ISLAMI BANK BANGLADESH LIMITED,
OPERATIONS WING, ENGINEERING DIVISION,
HEAD OFFICE, DHAKA.

Subject: Extension of Tender dropping date and Amendment of some terms & conditions relating to Tender for supplying & Installing of Power, Cooling, Environment control & other related Equipment/Items for relocated Disaster Recovery Site (DRS) & extended Data Centre (DC) of IBBL.

Tender RFP of supply & installation of Power, Cooling, Environment control & other related Equipment / Items for Disaster Recovery Site (DRS) of IBBL, as per pre-bid meeting held on 31st May, 2017.

Tender RFP of supply & installation of Power, Cooling, Environment control & other related Equipment / Items for Data Center of IBBL, as per pre-bid meeting held on 31st May, 2017.

Layout of Disaster Recovery Site (DRS) at 5th Floor of Bank's own building at New Market, Rajshahi.

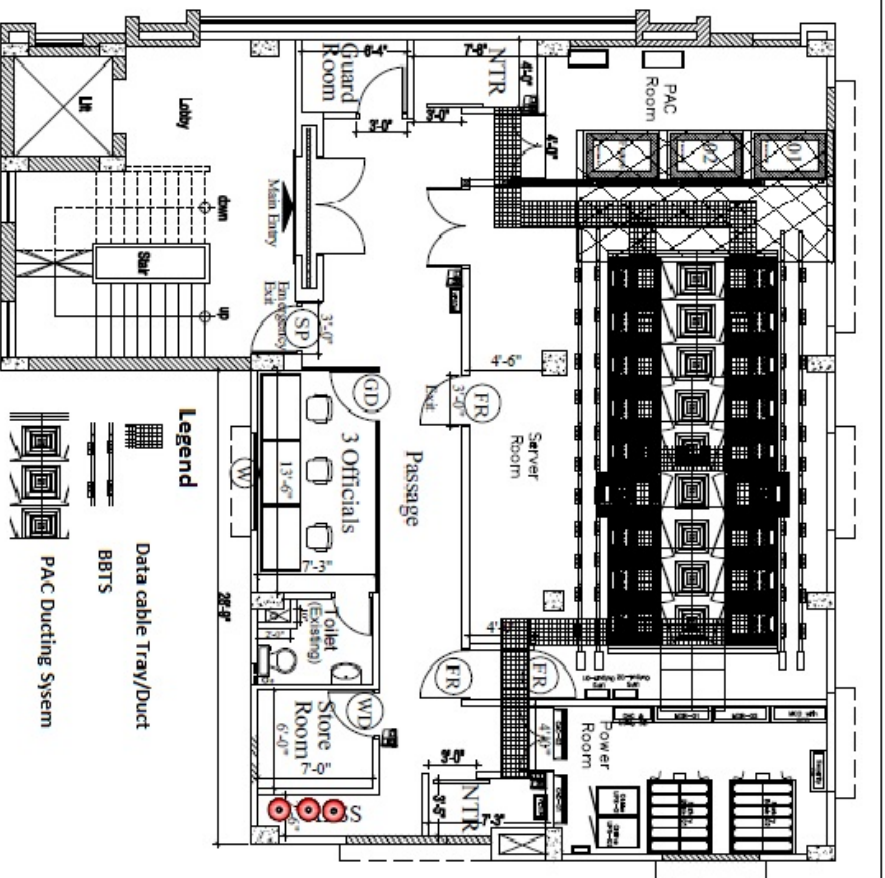
6.3 (Page-49)	Network Rack	Balanced Load rating 1500 kg	Balanced Load rating 1000 kg	
7.2 (Page-53)	Sliding Patch Panel 24 Port	Sliding Patch Panel 24 Port	Patch Panel 24 Port	
8.1 (Page-63)	DCIM License	-	Including required License for H/W use	
8.3 (Page-66)	Cat 6 Cable	23AWG 4pair LSZH U/UTP copper cable	24AWG (minimum) 4pair LSZH U/UTP copper cable	
8.5 (Page-67)	Portable KVM Tray with KVM Switch and Accessories	Brand: Please specify	Brand: APC/HP/Dell/IBM/Level1	
	Layout for Data cable, BBT System (For power) & Cooling System for DRS		Included herewith	
			Included herewith
